**Planning Delegated Committee
Meeting
Under Separate Cover**

8.1	DP/2021/1 - 89 Ross Watt Road Gisborne - Development Plan	
	Attachment 1 DP/2021/1 - Planning Delegate Committee - 89 Ross Watt Road Gisborne - Attachment 1 - redacted submissions	4

Figure 2: Gisborne Futures Draft Structure Plan - incorporating the Western Link

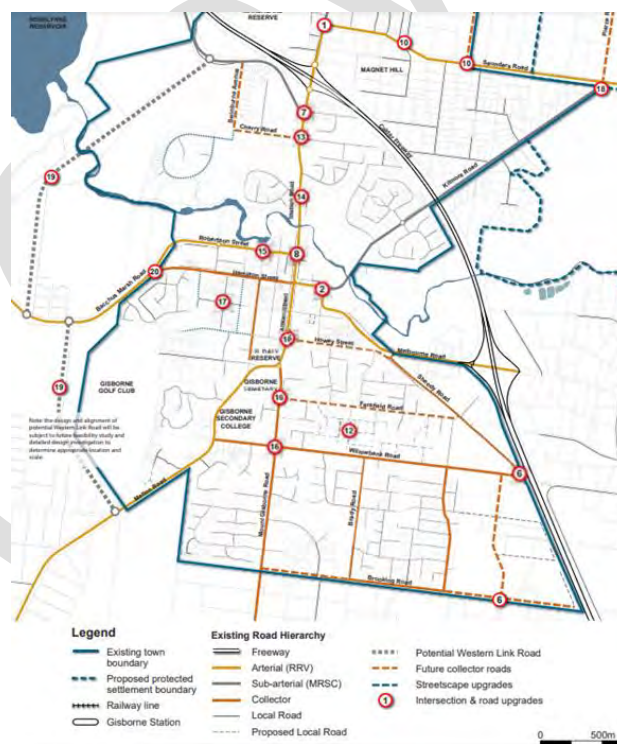
- A more comprehensive suite of traffic management options and commitments be considered, including but not limited to:
 - The role of a completed “Western Link” (as proposed in the Gisborne Futures Draft Structure Plan July 2020, Page 45, “Intersection & Road upgrades”. No 19 below)⁵ be considered.

- Redirection of traffic via the northern section of Ross Watt Road with the inclusion of a north-bound freeway on-ramp – to relieve pressure on the Cherry Lane/Station Road and Ross Watt Road/Station Road intersections;

Figure 19 Indicative Subdivision Layout Plan

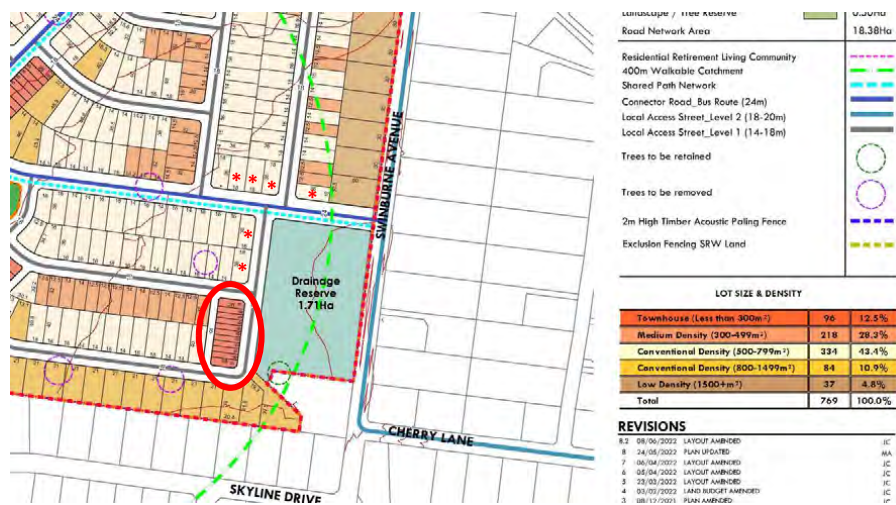
Furthermore, I refer to Figure 19 Indicative Subdivision Layout Plan (Pg. 33 of "Development-Plan-89-Ross-Watt-Road-Gisborne-July-2022.pdf"):

The current plan does not fully meet this expectation.

Figure 9-6 2046 Western Link Road and Reference Network, Worst V/C ratios

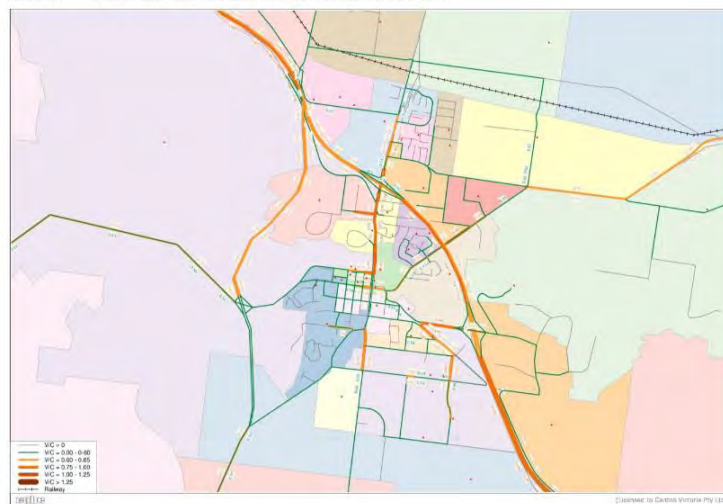
The Gisborne Futures project for the Macedon Ranges Shire Council has contracted the traffic modelling to Cardno Victoria Pty Ltd to produce a Gisborne Strategic Traffic Model Report. The current proposal from this modelling in the draft report, as a part of the future traffic management for Gisborne, includes a “Western Link Road”. This feature of the master plan will relieve the volume of through traffic from central Gisborne to and from Melton and Bacchus Marsh. It will be impossible to implement this significant feature, whether in the current proposed form or any alternatives, if the 89 Ross Watt Road Development Plan is approved in its current form.

The 89 Ross Watt Road Development Plan would cut-off access for any alignment of a western link road. By way of illustration, the Figure 9-6 of the Gisborne Futures Traffic and Transport Recommendations Report - Appendices (See below) clearly shows the blocking of access for this strategically important link road in the area of the 89 Ross Watt Road Development Plan. (I leave it to the reader to identify significant features in the Figure 9-6.) The Development Plan essentially provides a wall of sub-division from the established residential areas of Gisborne to the RossLynne Reservoir (not shown).
